### NEW - Q+A QUESTIONS + ANSWERS – Questions submitted through September 29, 2023

### Q+A QUESTIONS + ANSWERS – Questions submitted through September 22, 2023

### Q+A QUESTIONS + ANSWERS – Questions submitted through September 15, 2023

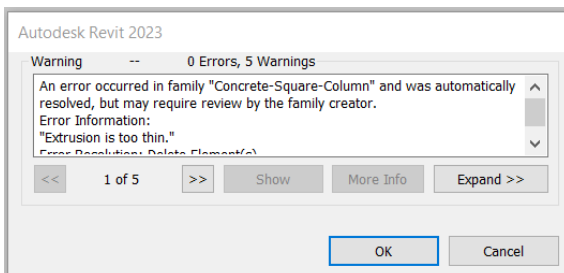
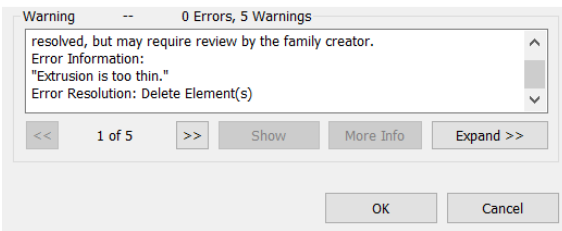
**Q:** Our students are using Revit 2023 and this is the message they receive when they open the file - how would you like them to proceed?

**A:** Have your students click on the "Upgrade the model" option, this won't affect the model and it's only asking because the model that was provided to us is on a previous version of Revit. There will not be any issues.

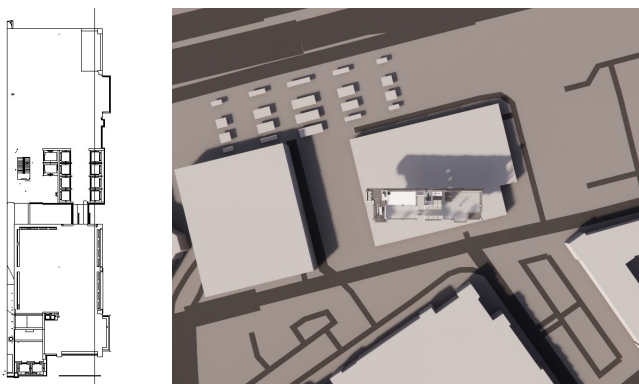
**Q:** An error occurred in family "Concrete-Square-Column" and was automatically resolved, but may require review by the family creator. Error Information: "Extrusion is too thin." Error Resolution: Delete Element(s). Is that what should happen? Do you want them to try to repair the model elements that will not transfer? See attached screen shots:

**A:** Steelcase did not develop the model ourselves, we only converted the file to CAD (2D and 3D) and created a viewer-only option. We received the file from the property owner where they scrubbed all of the interior architecture elements, etc. and it appears there are issues with the file. PLEASE NOTE, no students or programs should contact the building owner or property manager for any of these discrepancies. Per mentions in prior Q+A, please have your students remove any floating and/or foreign objects in the drawings and resolve any issues with architectural elements as needed so they can complete their design work. None of this will be part of the evaluation criteria for the judges.

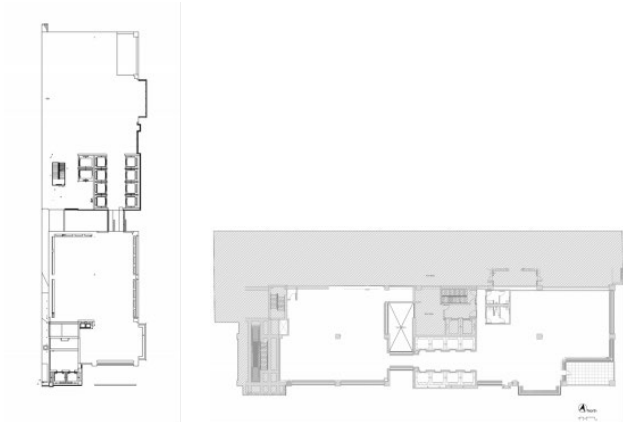
**Q:** Can shading devices (such as trellises, fabric shading devices, etc) be added to the patio space or can only furniture and planters be added?

**A:** Shades can be provided. I suggest looking at the Steelcase partner brand – Extremis – as they provide many solutions for outdoor. A fabric shading option could also be used; however, a built trellis wouldn't be permitted.

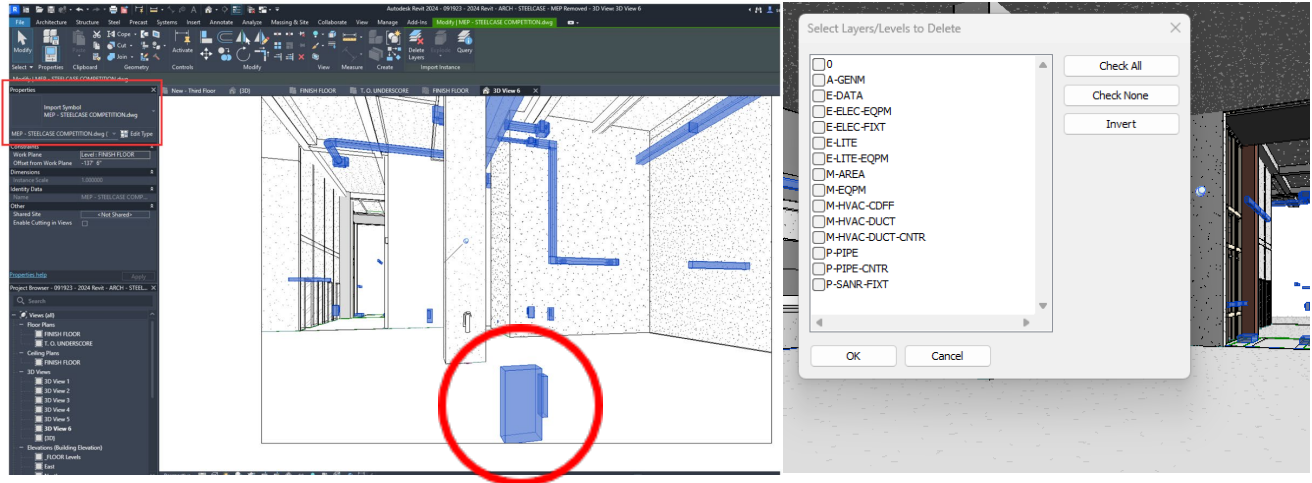
**Q:** Do you have any additional information for the light well beyond what is in the Revit file? The unfinished space photos show a boarded up wall.

**A:** We have no additional information for lighting other than what is shown in the Revit file and/or the photos of the space we have provided. This can be left to student interpretation for the competition. Regarding the photo of the space with the boarded wall, please refer to the Q+A we distributed last Friday (also linked on the NEXT competition website in the Resources section. This has been addressed.

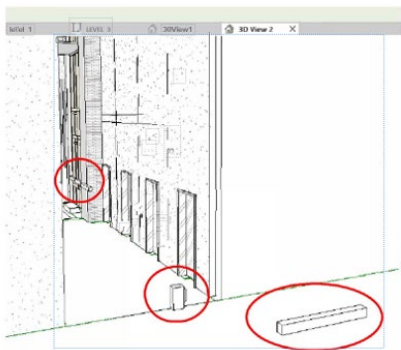
**Q:** In the previous Q + A, someone asked about "MEP Steelcase competition import symbol" and you answered with we should remove them. In another Q&A response about HVAC, we learn that we need to keep the HVAC systems in the ceiling. What confuses us is that both HVAC and MEP are linked in the Revit file. There is a way to delete individually, but we would need clarification from you on which HVAC elements to keep. Is there any way for Steelcase to fix the file and re-post for everyone? Or give us clear direction on what to delete versus keep?

**A:** We understand there are "floating" objects labeled as MEP in random places on the floor or along walls like I've circled above in your drawing as well as below from the prior Q+A. These can be removed. The items that shouldn't be removed are along the windows (under the floor) as mentioned in prior Q+A as well as items from ceiling, internal to walls, etc. For the purpose of this competition, students may remove any of these foreign objects as the MEP will not be evaluated as part of the competition.

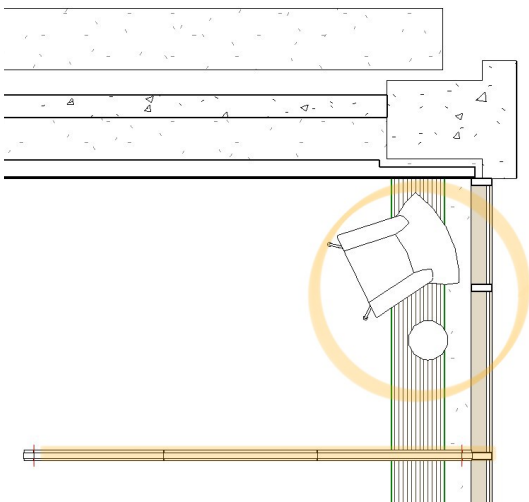
**Q:** Your last Q&A clearly stated no materials can cover the floor HVAC grills around the inside perimeter of the curtain walls. However, 1. can any FF&E be placed over the grills with or without any limitations? Ex. weight or material of FF&E? 2. Can a VIA curtain wall and panel stand over the grill if the VIA Junction End is placed on the concrete floor in between the building's curtain wall and grill? Please see image below for details to both these questions.

**A:** No objects may be placed on or above the grates on the floor. A wall or partition may not cross over the grates; however, these are not continuous. A wall could connect into a column along the exterior curtain wall.

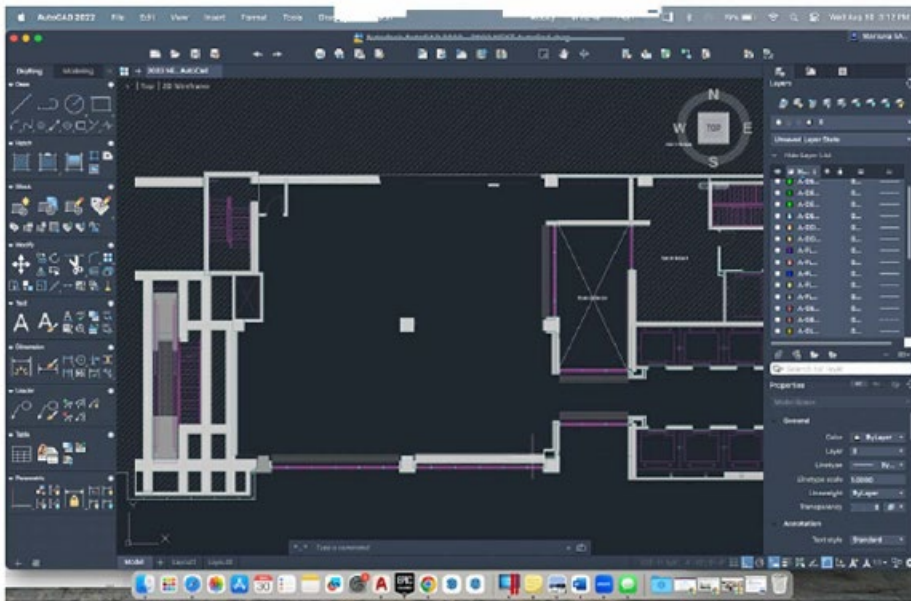
Q: Is this wall open to another room? The north wall in the left side of the floor plan...the thin part of the north wall.

A: The wall in question is a Concrete Masonry Unit (CMU) wall and on the other side of this wall is the parking garage. The interior side of the wall is having sound batting added and for some reason it is showing up this way in our drawings. Please see a photo of the wall while under construction as it is being prepared for sound batting. For this competition, this wall can be considered as normal construction.

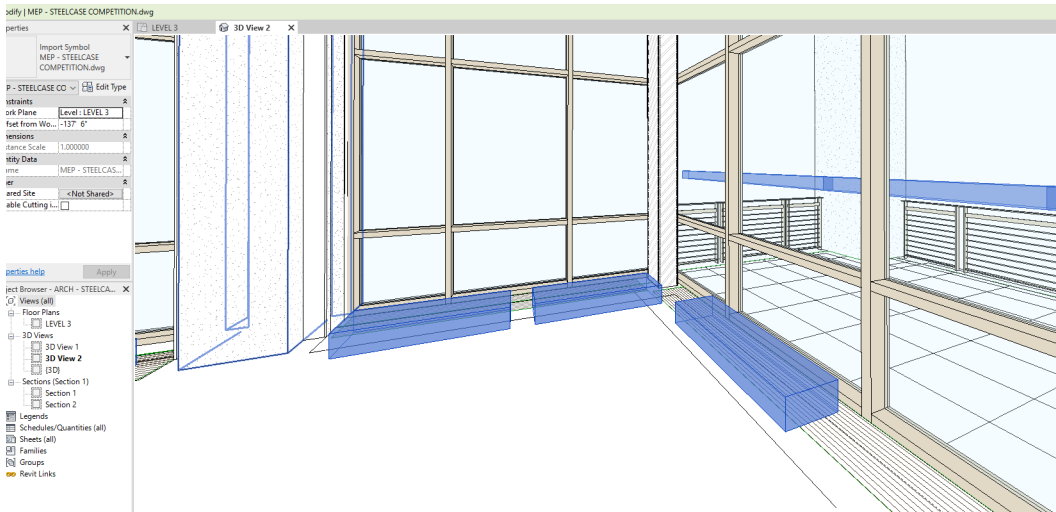
**Q:** Please see attached image. In the 3D in the Revit file, it appears that these rectangular elements are labeled at MEP. Are they supposed to be above or below and we should move them or hide them in the file?

In the finished photos of the space, they don't appear and there appears to be unobstructed floor-to-ceiling curtain wall at the east and south perimeter. My students are wanting to double check that there are no obstructions on those walls.

**A:** The elements labeled as MEP are errors on the drawings. These can be deleted or hidden within the file. What is shown as unobstructed curtain walls on the south and east sides of the plan are indeed that. No obstructions on the walls where indicated.
